Rezoning Transportation Analysis

Petition Number: 2021-079

General Location Identifier: 15705136

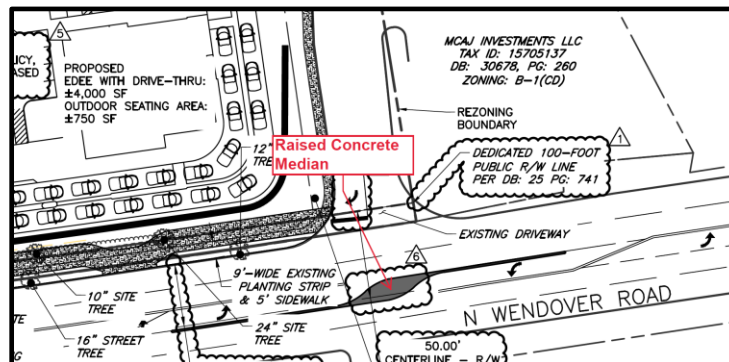
1. ~~**Curbline:** The proposed zoning district has a setback measured from back of the existing or proposed future curbline.~~
 - a. ~~**North Wendover Road:** The future location of curb and gutter is in its existing location.~~

~~Label and dimension the curb and gutter from the centerline for each road on the site plan.~~
